PSE RESPONSE TO PUBLIC  
COMMENTS ON ELCC  
CALCULATIONS AND USE

*Prepared pursuant to Order #1 in  
WUTC Docket UE-210220*

December 3, 2021

**Figure 2. Dispatch Plot, Week of January 25 (2027), PSE IRP Base Case**

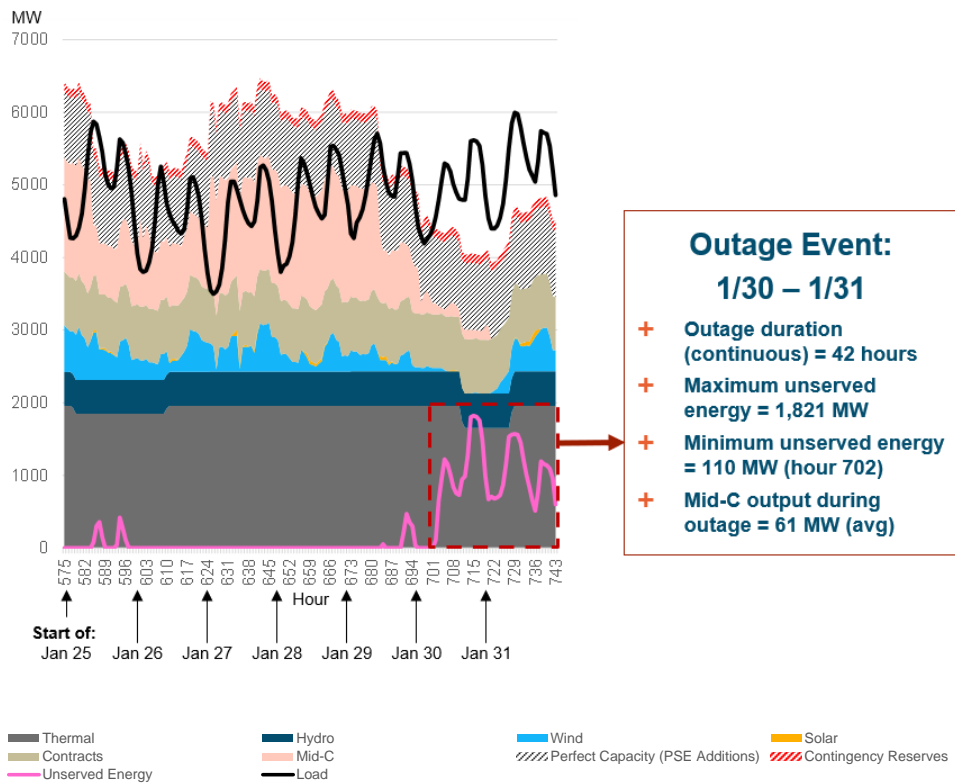
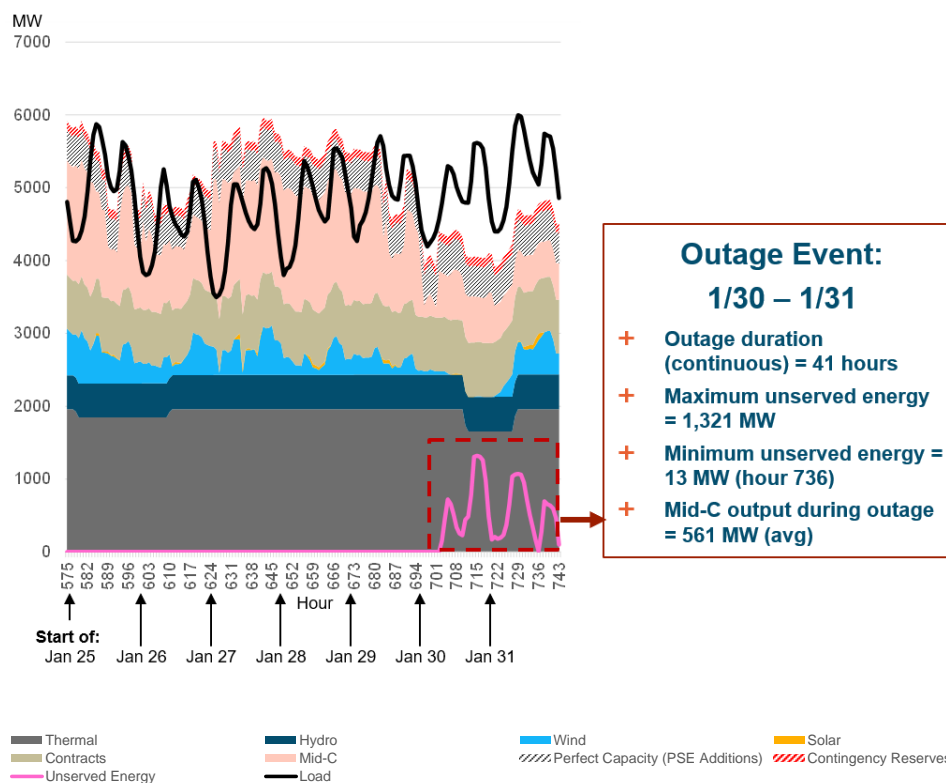
To illustrate the impact of potential additions to regional capacity, E3 generated the dispatch plots below from the week of January 25, 2027 in the PSE Base Case. This week was chosen because of a 42-hour outage that occurs in draw 1687 (out of 7040), representing the combination of hydro calendar year 1947 (in which streamflow was the lowest of all 80 hydro years) and temperature calendar year 1943. In Figure 2, PSE's modeled dispatch is shown. In Figure 3, E3 has added 500

MW of available hourly capacity from Mid-C during the outage events in the Base Case and removed 500 MW of perfect capacity from the PSE system.

As shown above, modifying the PSE Base Case so that Mid-C output is increased by 500 MW during unserved energy events reduces the duration of the 42-hour outage by only 1 hour, illustrating the impact of Mid-C on the outage characteristics against which battery storage is tested. However, it can also be seen that increasing the Mid-C market availability by an additional 500 MW would reduce outage durations substantially by effectively segmenting the long-duration outage shown above into multiple smaller-duration outages.

To assess the potential impact of changes in PSE’s approach to the external market on ELCC values, E3 recommends an additional GENESYS model run (and subsequent calibration with the WPCM model) where reliability-driven capacity is added to the broader region to achieve a 5% LOLP, as well as the PSE system. PSE should then perform ELCC calculations with a reliable system (to a 5% LOLP standard) where both the Mid-C market and PSE system are in a reliable state. How the battery storage ELCCs change could inform how PSE possibly rethinks its current modeling of the Mid-C market. If the changes to ELCC results are negligible then PSE would be comfortable that its current modeling is sufficient. If the ELCC results change significantly then broader consideration would need to be given to what reliability standard (and relatedly how much added reliability-driven capacity) is reasonable to assume given PSE’s expectations for future capacity additions and retirements in the region.

Figure 4. Dispatch Plot, Week of January 14 (2027), PSE IRP Base Case

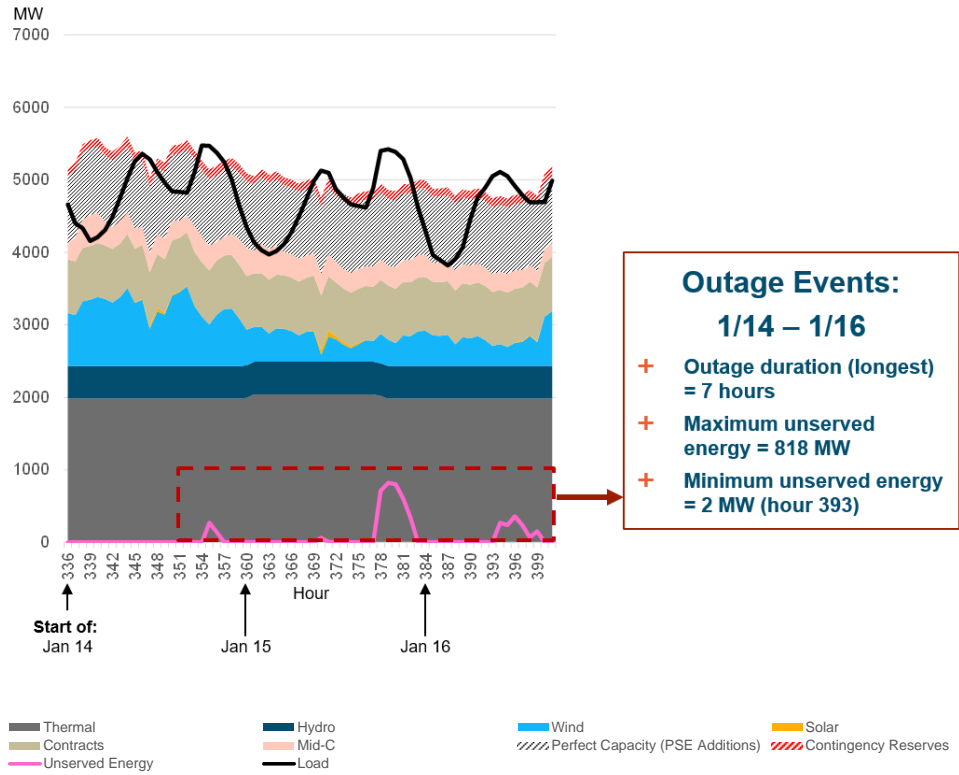
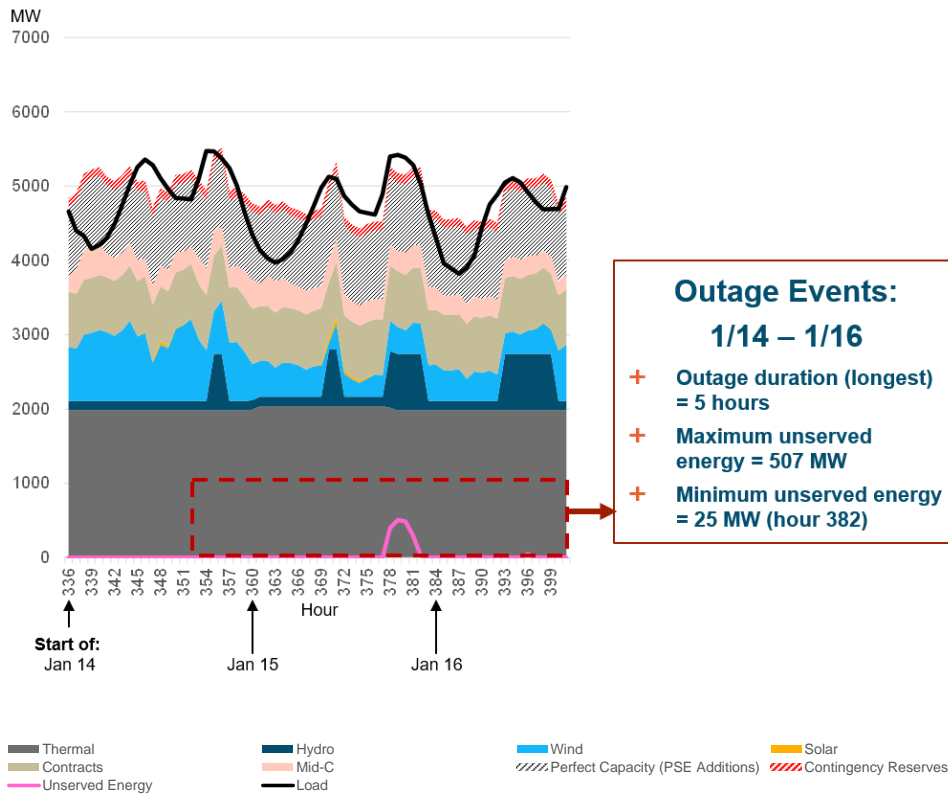
To illustrate the impact of changes in PSE's approach to modeling hydro operations, E3 generated the dispatch plots below from the week of January 14, 2027 in the PSE Base Case. This week was chosen because it contains multiple shorter-duration outages in draw 1687 (out of 7040), representing the combination of hydro calendar year 1947 (in which streamflow was the lowest of all 80 hydro years) and temperature calendar year 1943. In Figure 4, PSE's modeled dispatch is shown. In Figure 5, E3 has modified the capabilities of hydro resources to operate with energy limitations (50% capacity factor,  $p_{min}$  of 25%) and dispatch capabilities (i.e. output can be increased to  $p_{max}$  when there is unserved energy).

As shown above, modifying hydro resources so they are energy-limited and dispatchable illustrates the ability of hydro to minimize unserved energy needs over shorter-duration periods (e.g., 4-6 hours).

For future IRP cycles, E3 recommends that PSE update its modeling to incorporate hydro dispatch capabilities and hydro energy limitations. E3 recognizes, however, that modeling hydro as flexible is highly complex, as the flexibility depends on water conditions, operational constraints, and other factors that are difficult to quantify in a planning model.

Figure 6. PSE Temperature Year Data, by Source

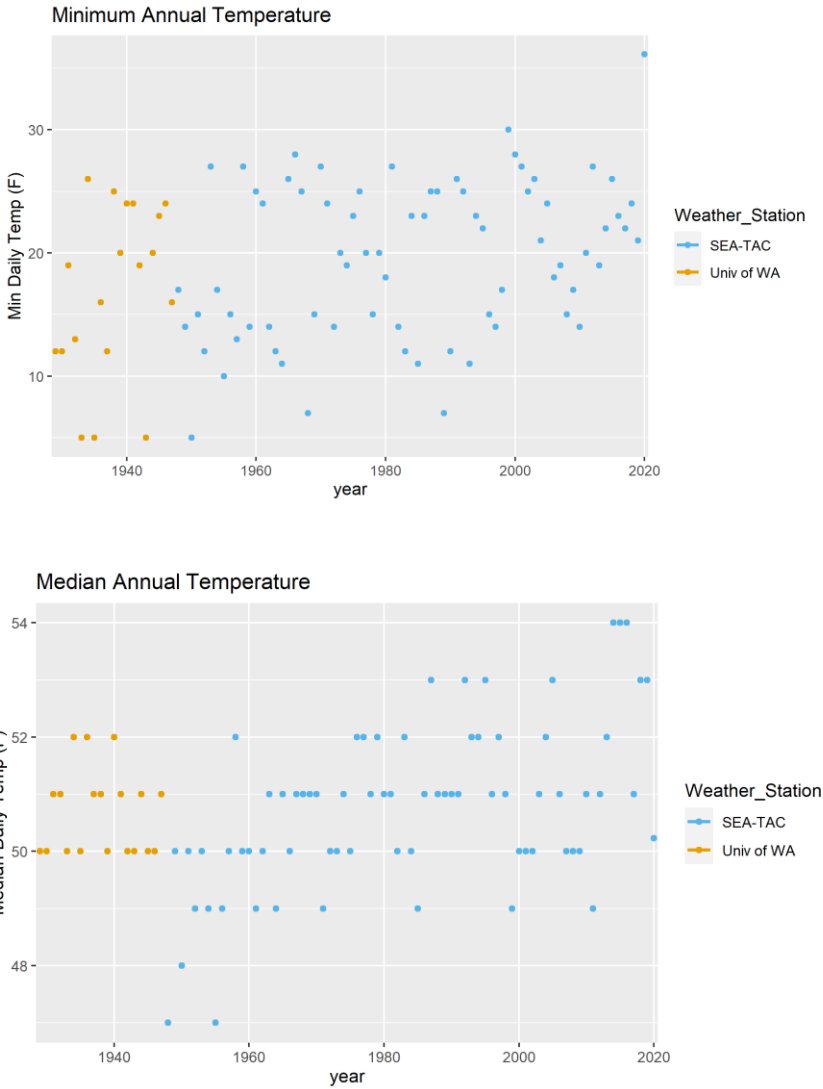
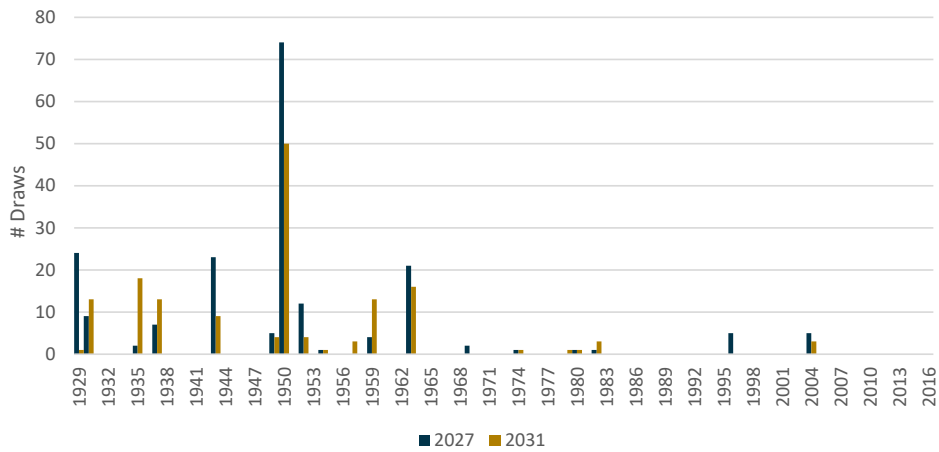
This brings up important questions regarding whether the synthesized hourly temperature data is having an impact on PSE's modeling and ELCC analysis. Unlike the outage events across hydro input years that are relatively evenly distributed, outage events in PSE's modeling are not evenly distributed across temperature input years. 33% - 35% of the simulated draws that have loss of load events in January 2027 and January 2031 occur in the temperature years prior to 1948, a period representing 21% of all weather years.

However, E3 analyzed this pre-1948 temperature data and found that it is reasonable and does not demonstrate any apparent bias compared to the other temperature years that would unfairly impact ELCC results. The minimum annual temperatures, as well as the median temperatures do not show a clear bias in the data that is formed with the synthesized data.

But looking at the temperature data further reveals that nearly 95% of the simulated draws that have loss-of-load events in January 2027 and January 2031 occur in the first half of the temperature years, prior to 1972 (see Figure 7).

This raises important questions regarding whether, given that PSE is a winter-peaking system, there are clear warming trends that make the use of temperature data as far back as 1929 less useful. Moving forward, PSE’s winter peaks may be reduced relative to summer peaks based on more recent climate warming trends, which has the potential to impact PSE’s resource planning.

E3 recommends that PSE analyze the impact of the Temperature Sensitivity shown in its IRP on the current RFP and investigate potential modifications of the temperature data set to reflect a changing climate in light of its findings. This is especially relevant to the bid-specific analysis that will be conducted in Phase 2
